UNITED STATES PATENT AND TRADEMARK OFFICE

APPLICATION NO.	FILING DATE	FIRST NAMED INVENTOR	ATTORNEY DOCKET NO.	CONFIRMATION NO.
10/753,730	01/06/2004	Jonathan Norberg	70906-010100	6358

Office Action Summary

DETAILED ACTION***Drawings***

7.

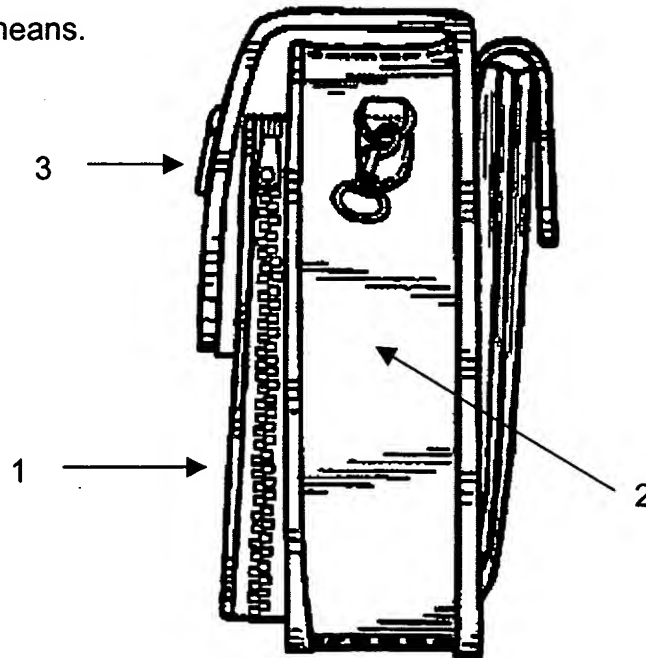
7. Claims 1 and 6 rejected under 35 U.S.C. 102(b) as being anticipated by Boch (US 1,184,311).

Regarding claims 1 and 6 Boch discloses a personal article holder, which is shown to be releasably secure, with adjusting means about the leg of the user. See figure 1. It can be shown that Boch is also be capable of releasably securing around the upper arm of the user, by means of buckles 13 and elastic strap 11. The personal article holder of Boch includes a plurality of pockets, each having a front and back wall (figure 1, also col. 3 line 25-30), interconnected side walls, a closed off bottom and a open top, each of which is mounted to a base (col. 2 line 91-96). The interconnected sidewalls of Boch are considered to be the stitching found along each side. Each pocket is also shown to be closed off by a flap 6, which can be removably secured to the front of each pocket by fastening means
